## Change Notification

FN3359HV series.

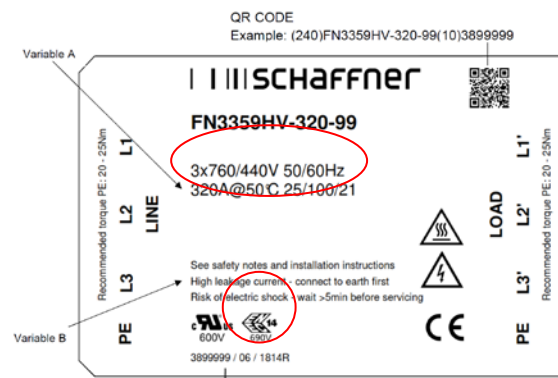
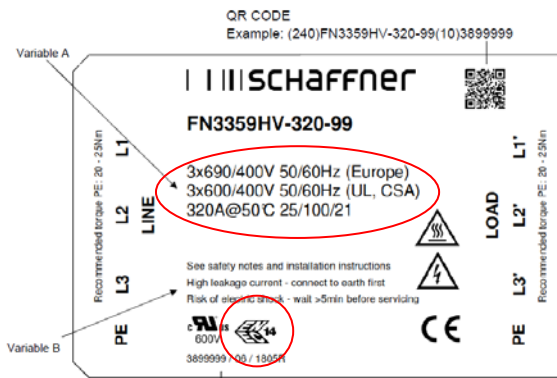
The higher voltage level on the label will be changed as follow to 760 VAC:

**Before:** for products < 1600A

**New:** for products < 1600A

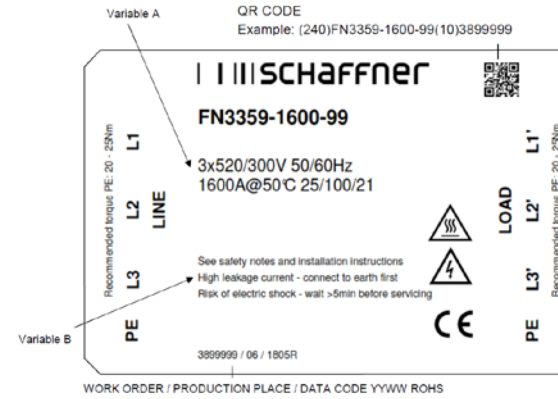
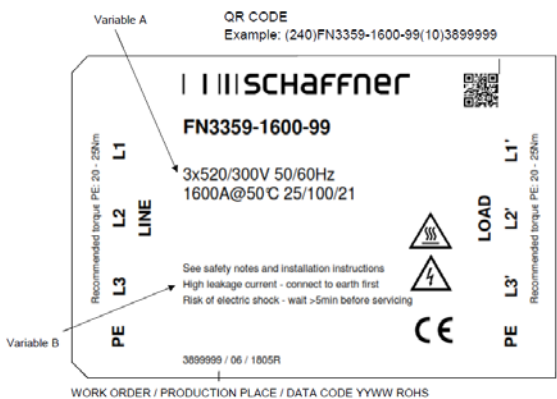
**Before:** for products ≥ 1600A

**New:** for products ≥ 1600A

Material	Description	Variable A	Variable B
801005	FN3359-1600-99	3x520 / 300V	X
801019	FN3359HV-1600-99	3x690 / 400V	X
811296	FN3359HVPV-1600-99	3x690 / 400V

Material	Description	Variable A	Variable B
801005	FN3359-1600-99	3x520 / 300V	X
801019	FN3359HV-1600-99	3x760 / 440V	X
811296	FN3359HVPV-1600-99	3x760 / 440V
